MITSUBISHI FUSO
TRUCK OF AMERICA, Inc.

SERVICE INFORMATION BULLETIN

Bulletin Number: 12-001 Models: FE/FG Issue Date: August 2012

SUBJECT:
Fuel injector gasket redesign.

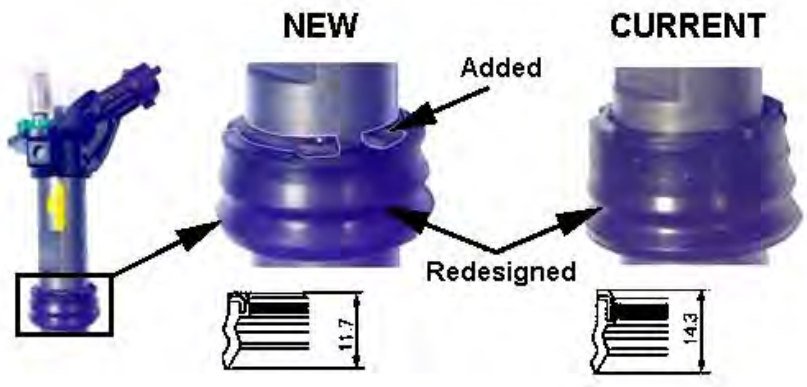
DESCRIPTION:
The injector gasket has been redesigned and a snap ring has been added to hold the gasket in its proper location.

Note: Either of the current parts must be replaced with all three of the new parts, as the parts are not interchangeable.
